TACKLE BOX

RESTAURANT RENOVATION AND DECK ADDITION

Planning Review Board
Revision

Pages now labeled Approved or Revised
with short description. Narritive Attached

Proposed Floor Plans
Second Floor
Item #21.2

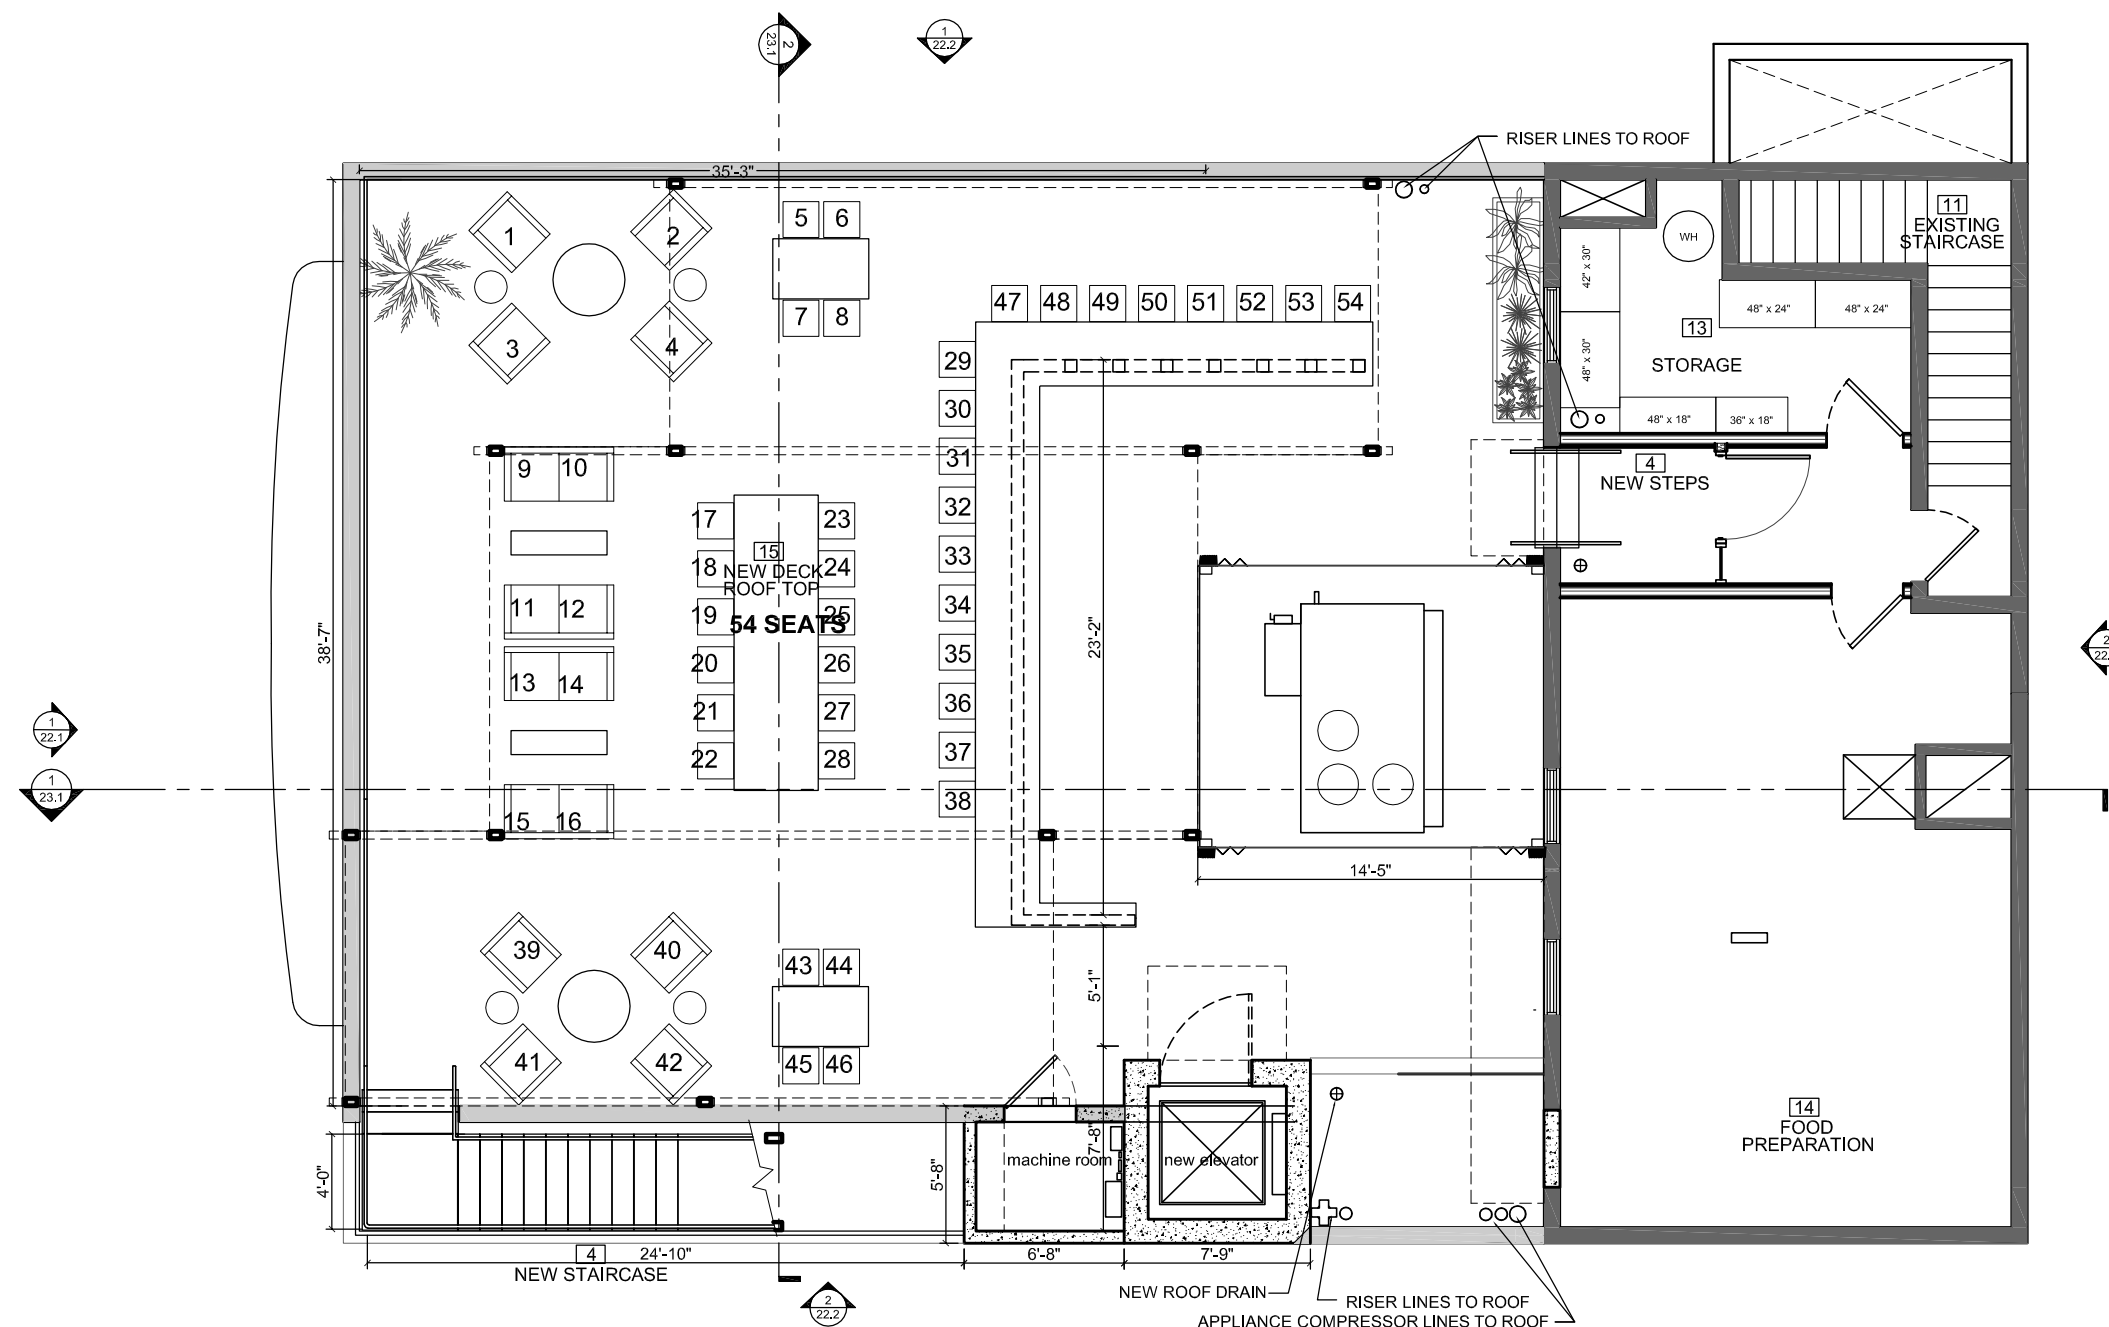
PROPOSED CHANGES/ SITE CHANGES

-8 SEATS ADDED

-EGRESS ROUTE UPDATED (STAIR ACCESS THROUGH BUILDING NOT SIDEWALK)

**Proposed
Elevations
Item #22.1**

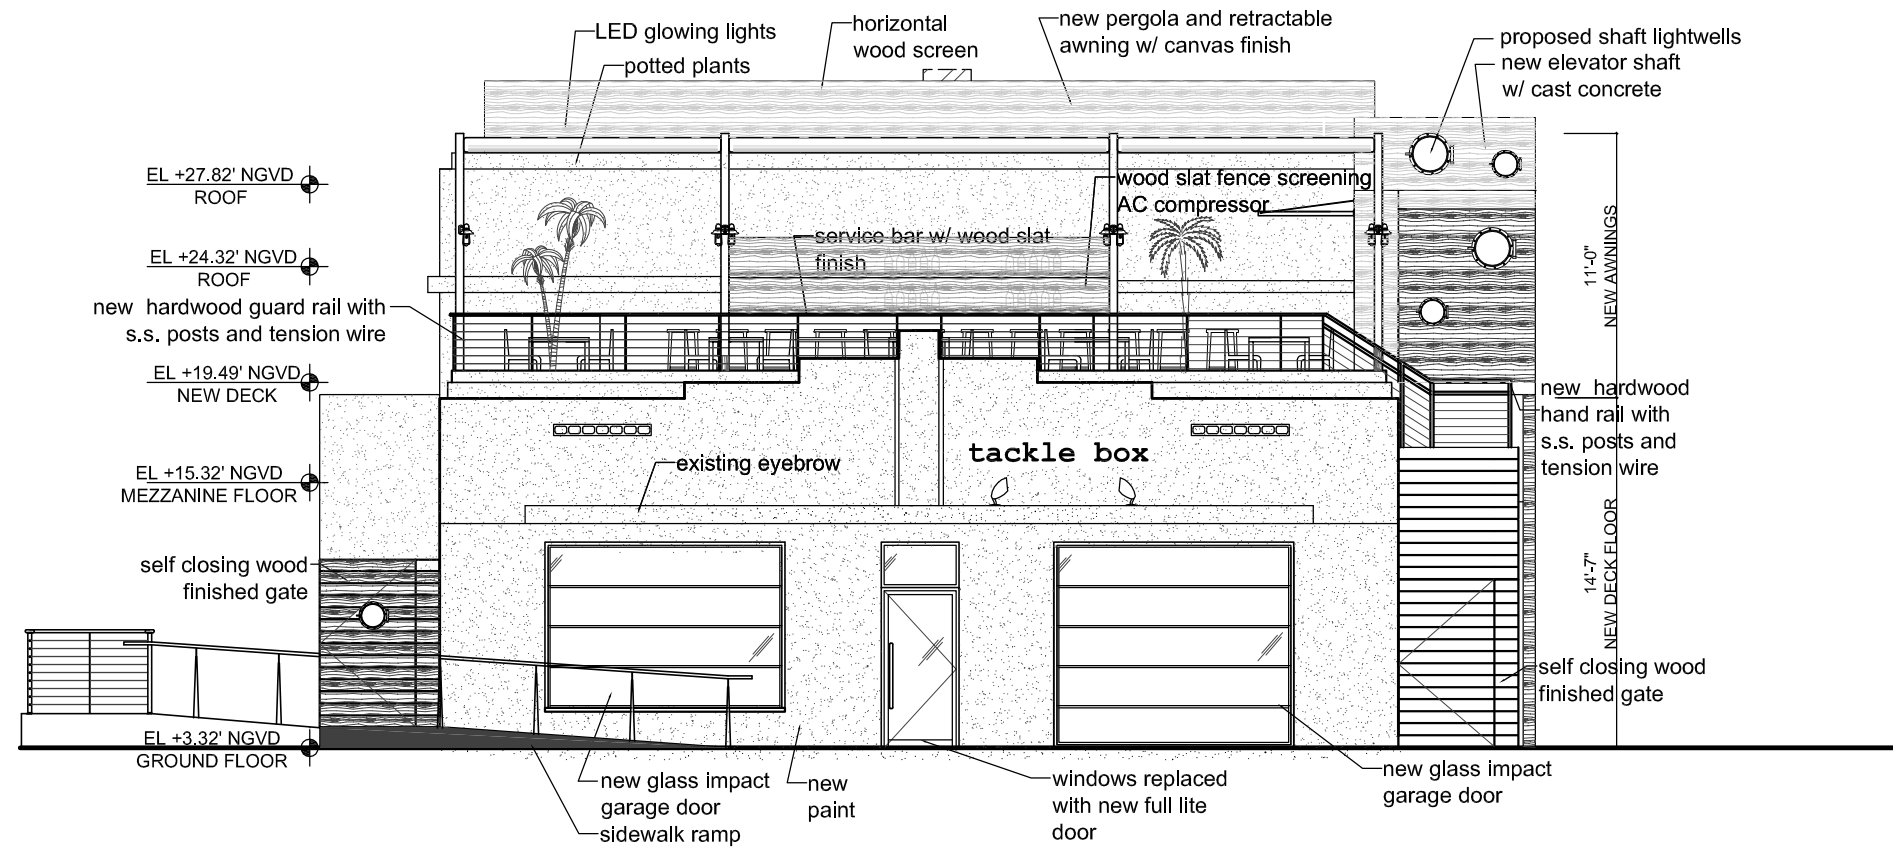
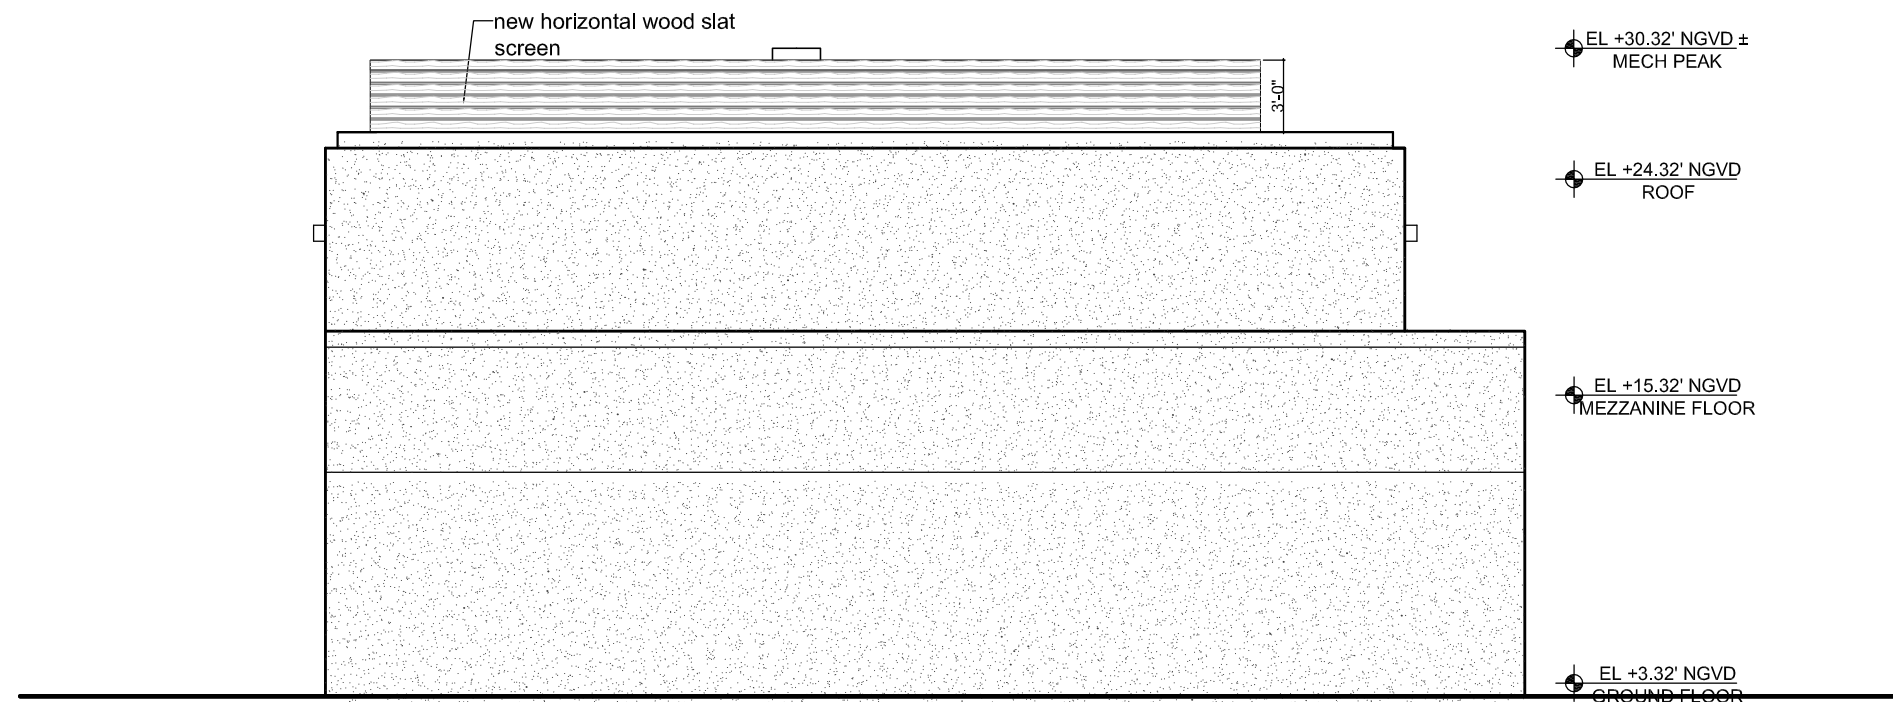
PROPOSED CHANGES/ SITE CHANGES -ROLL UP, STOREFRONT REVISED

**Proposed
Elevations
Item #22.2**

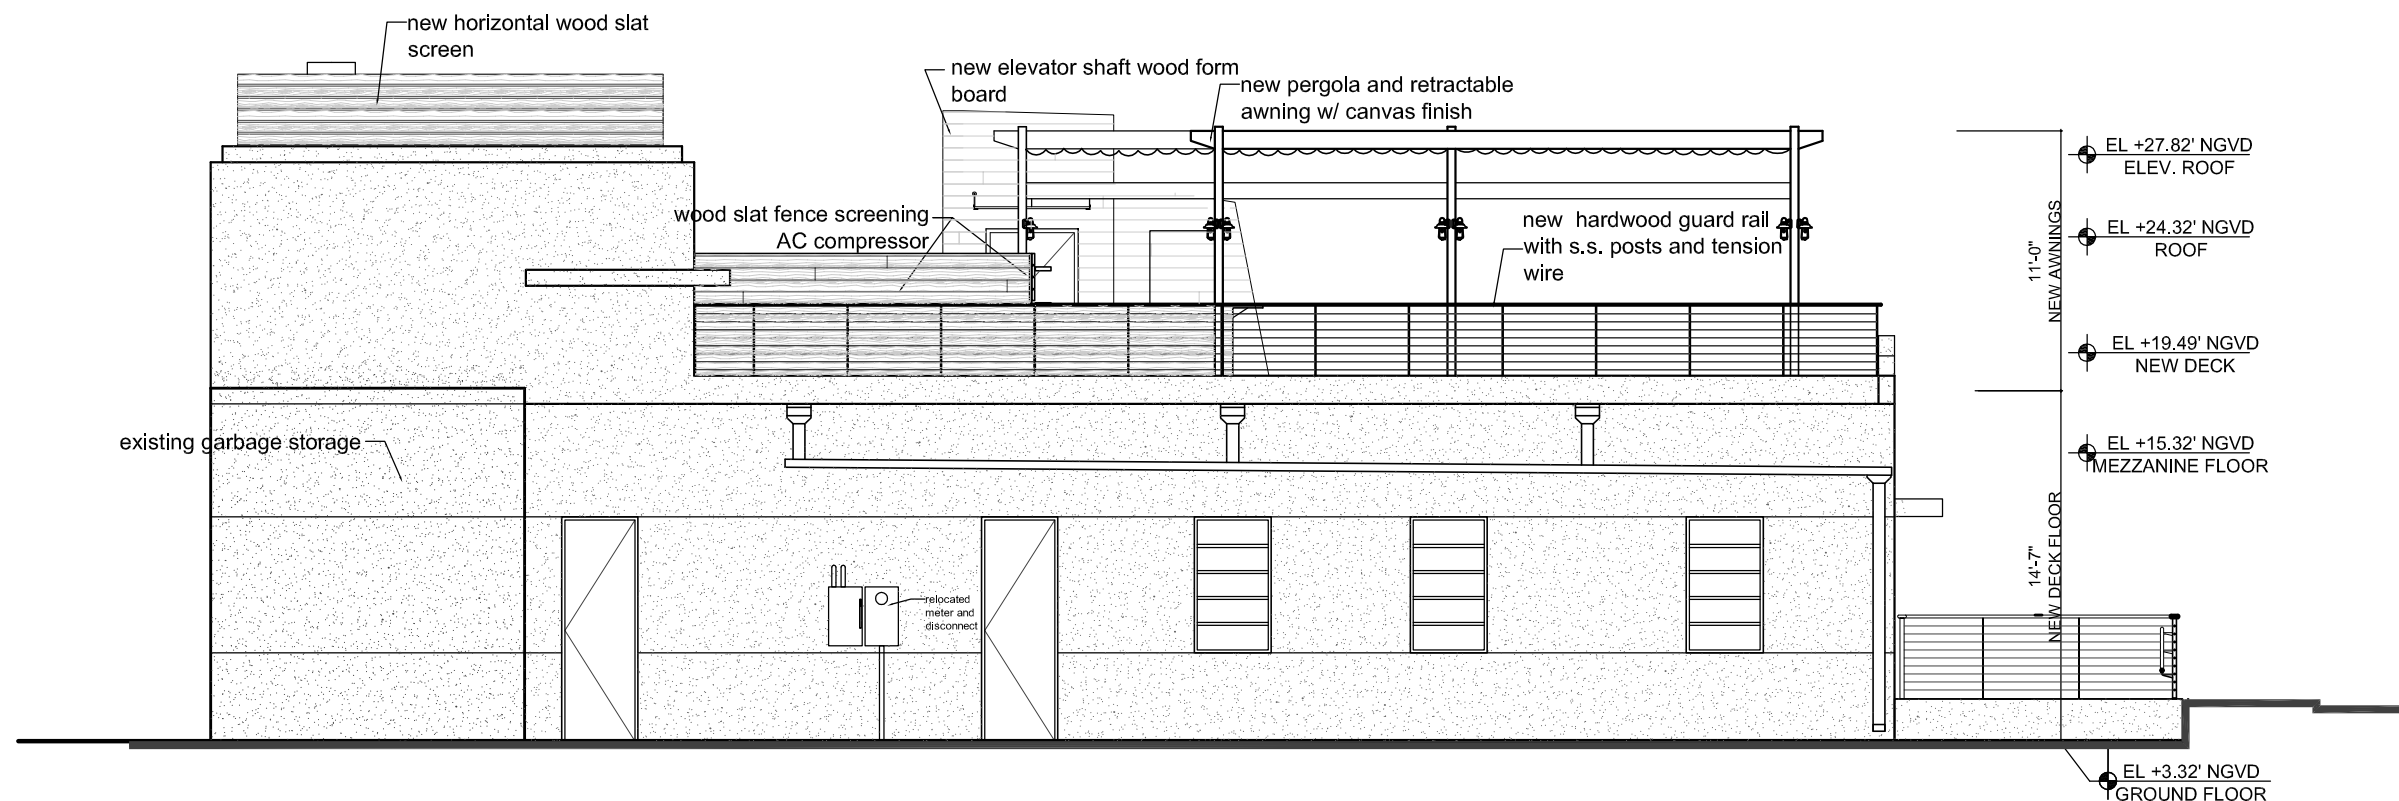
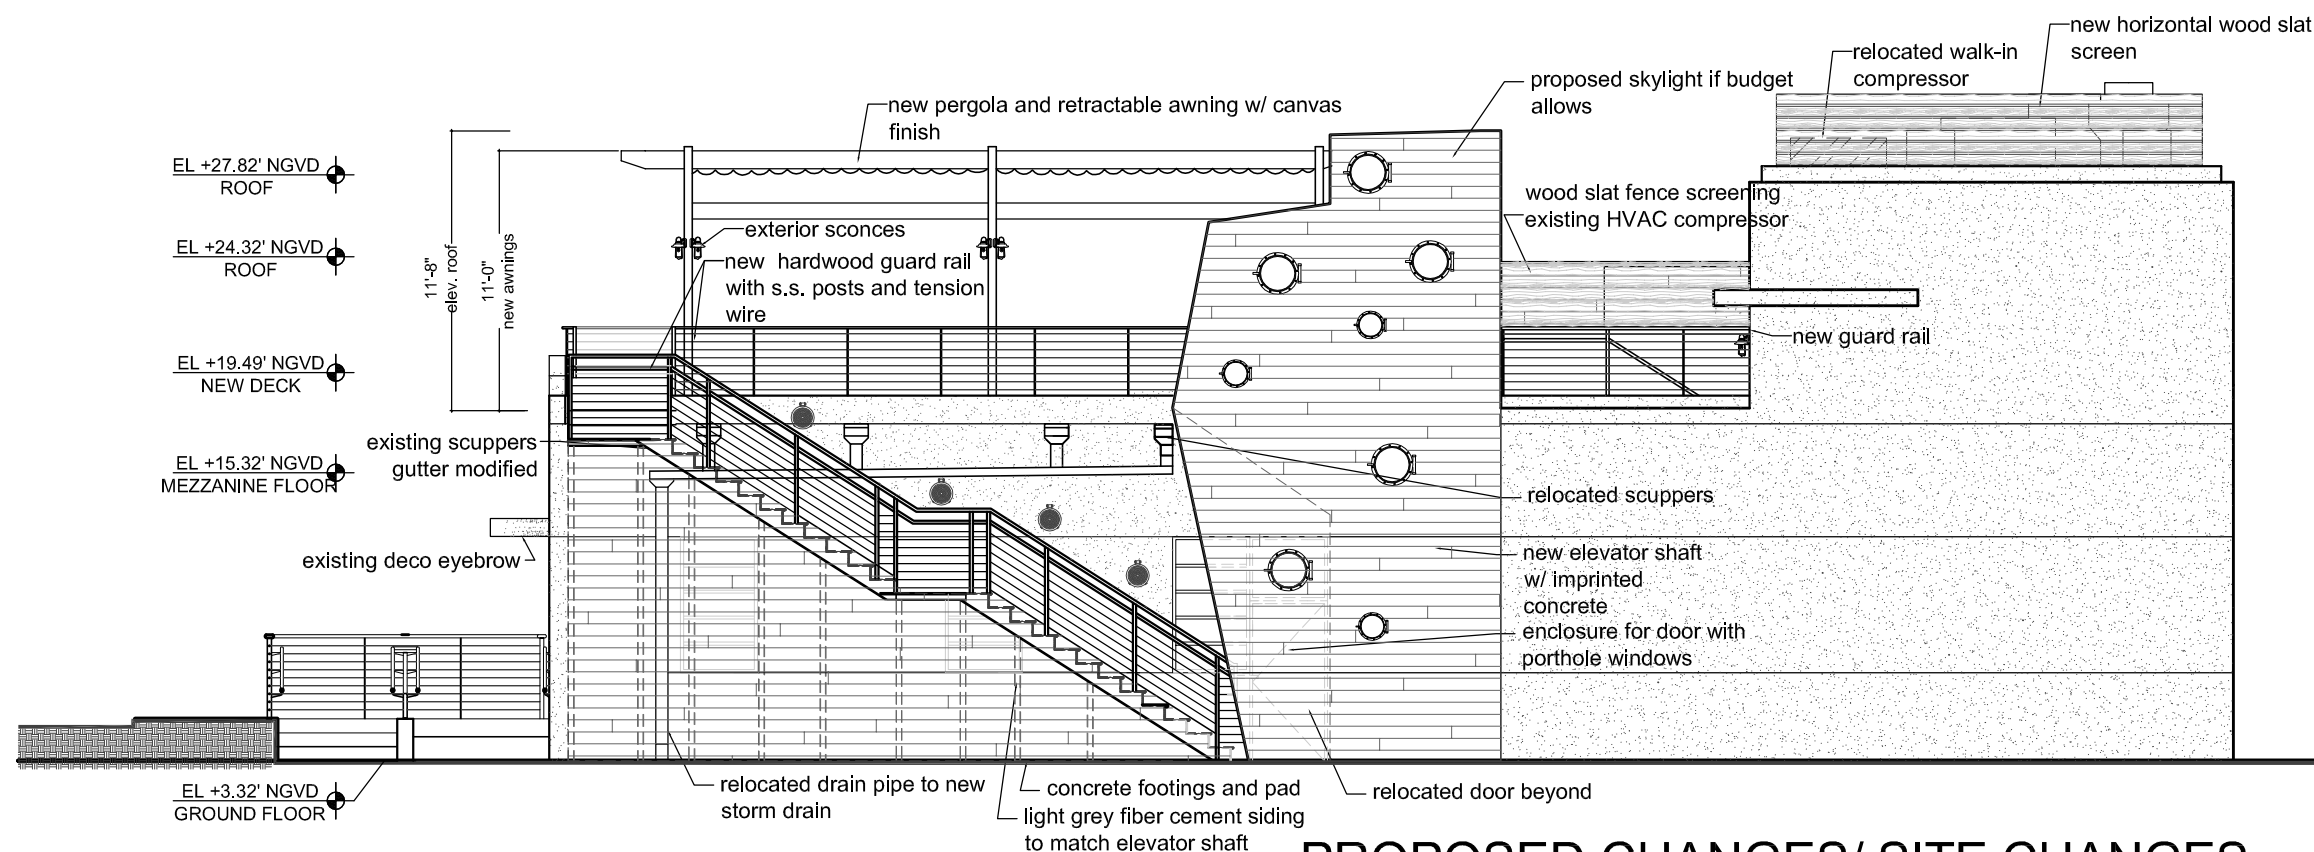
PROPOSED CHANGES/ SITE CHANGES
-STAIRCASE RISES EAST TO WEST
-SIDEWALK ELEVATION
